Montana Department of Transportation

Memorandum

To: Distribution *DAW*
Prepared By: Deb Wambach, Butte District Biologist
Date: April 12, 2021
Subject: MDT Wildlife Accommodation Recommendation Memo (WARM)
NH 49-1(25)9
Stone Creek - North
UPN 7931000
Work Type 140 - Reconstruction – without added capacity

CN 7931000 Stone Creek - North Wildlife Accommodation Map

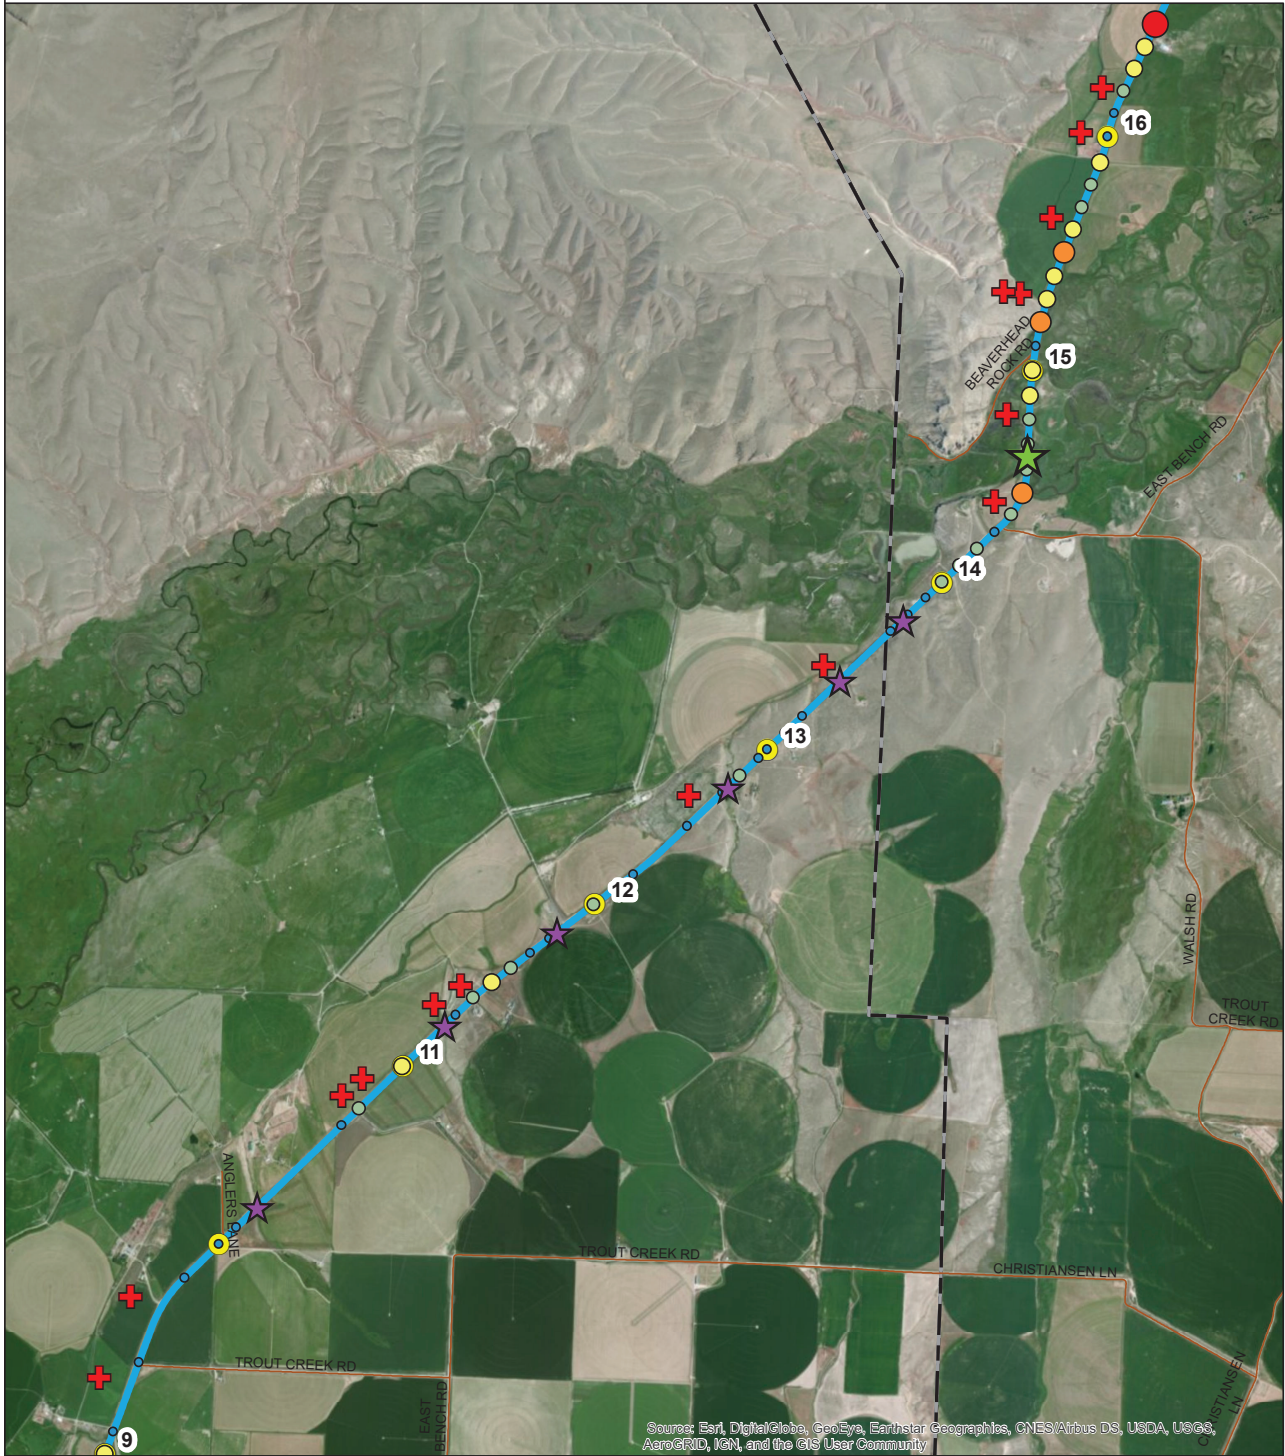
Wildlife vehicle conflicts and collisions are documented throughout the project limits and are concentrated through the Beaverhead River bottomlands and through the northern end of the project and beyond. However, while white-tailed deer carcass counts and collisions are elevated throughout the project limits, they are not as high as several other similar road segments in the general vicinity. Given the current resident population numbers, the white-tailed deer conflicts within the project area present a greater safety concern than a conservation concern, and wildlife accommodation recommendations commensurate with the level of concern and resulting in the greatest benefit should be implemented.

- 1) The existing bridge across the Beaverhead River is a 150-foot long two-span structure. The proposed bridge is a 181-foot long single-span structure that will be shifted to the east of the existing bridge alignment. The new structure will eliminate the center pier and extend the bridge length approximately 30-feet. A comparison of vertical clearance estimates between the two structures is provided in Table 4 below.

From Geotech borings, it appears there is approximately 1.5-feet of topsoil over gravels along the southern span inside of the channel meander. To gain vertical clearance and provide a pathway enticing to wildlife, it is recommended that a 3-foot-wide trail be excavated through the southern span of the structure by removing the topsoil overburden down to approximately between 12-18-inches, creating a “game trail” through the floodplain beneath the structure.

Wildlife barrier fencing is recommended to extend from the southern abutment to the vicinity of East Bench Road and from the northern abutment to the vicinity of Beaverhead Rock Road or beyond. There appears to be at least one driveway and one farm field approach that will require treatment within the fenced section. The fencing configuration in relation to the proposed fishing access located at the northwest abutment will also require further evaluation. Coordination with the adjacent landowners will be required.
